## DART

PUSHER, CLUTCH IN RACE INSTALLATION

RBW6305G04731-3G-1

(-1)

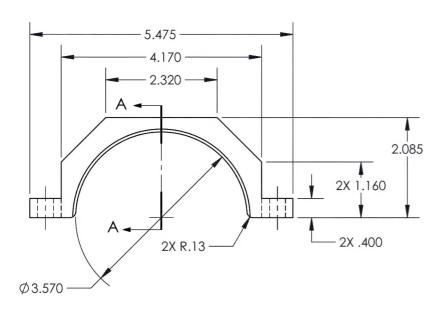
REVISIONS						
REV	ECR	DESCRIPTION	DATE	INITIAL	APPROVED	
1		-1 CH'D DIM .865 TO 1.097. ADDED MISSING DIM R.125 (2X).	1/20/2011	RJC	RW	
3		-1 CH'D DIM'S TO MEET FACTORY PART,	12/14/2011	RJC	SE	
4		-1 CH'D DIM'S TO MATCH PREVIOUS REV DESIGN.	1/30/2013	BIM	SE	
5	16-0193	-1 CH'D DIM'S WAS .393 IS 2X .393, WAS 2X .313 IS 2X .332, WAS .060 X 45° IS .06 X 45°. DELETED ENGRAVE NOTE.	10/27/2016	RJC	SM

CONE

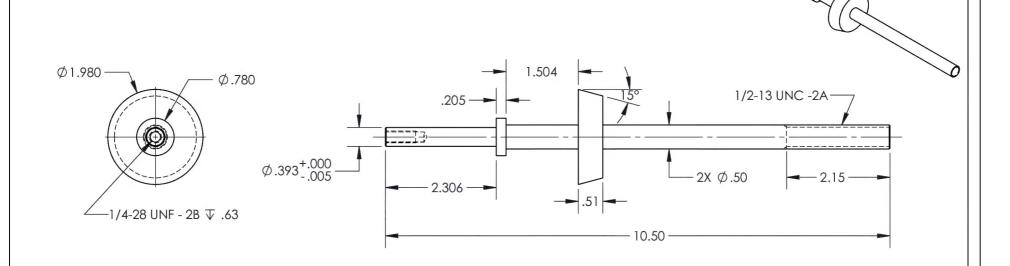
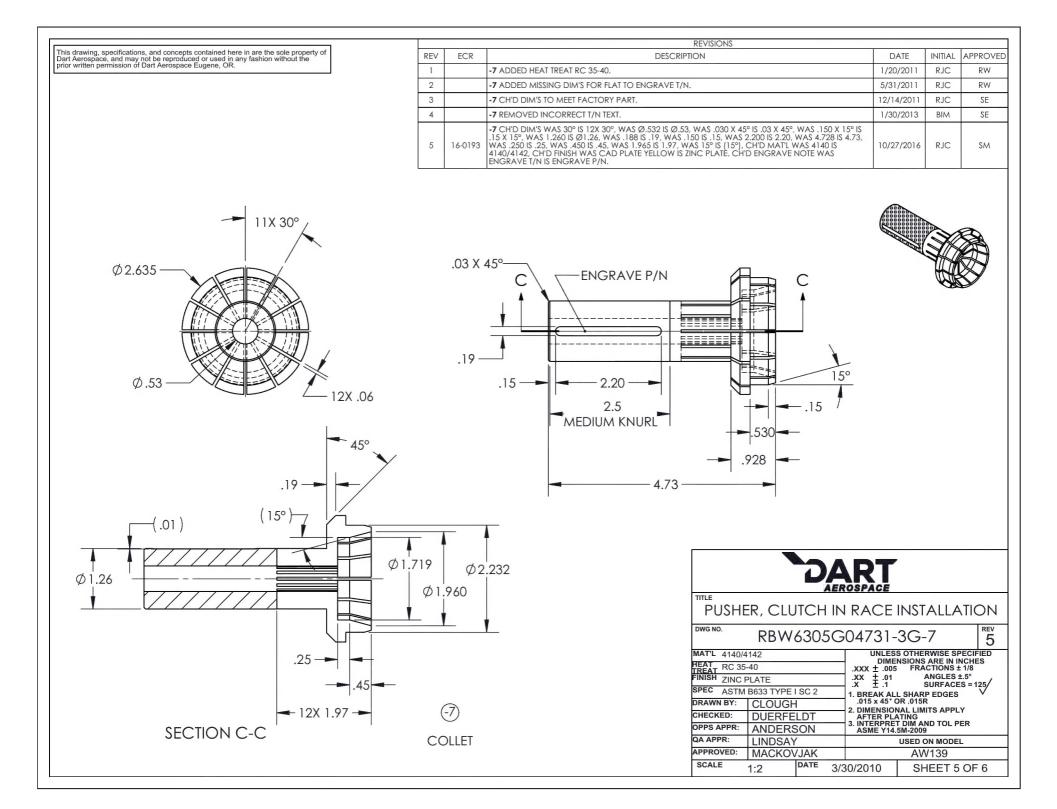
REVISIONS					
REV	ECR	DESCRIPTION	DATE	INITIAL	APPROVED
1		-5 CH'D MATERIAL FROM 4140 TO 4140 Q&T.	1/20/2011	RJC	RW
2		-5 ADDED NOTE 2.	5/31/2011	RJC	RW
3		-5 CH'D DIM'S TO MEET FACTORY PART.	12/14/2011	RJC	SE
5	16-0193	-5 DELETED DIM'S 1.707, 5.975, .350, Ø.125 THRU ⚠. CH'D DIM WAS 10.500 IS 10.50, WAS .500 IS 2X .50, WAS .510 IS .51, WAS 1/4-28 UNF ₹.625 IS 1/4-28 UNF -2B ₹.63, ADDED HEAT TREAT RC 28-32, CH'D FINISH WAS CAD PLATE YELLOW IS ZINC PLATE, CH'D MAT'L WAS 4140 Q&T IS 4140/4142, DELETED NOTE 2. DELETED ENGRAVE NOTE.	10/27/2016	RJC	SM
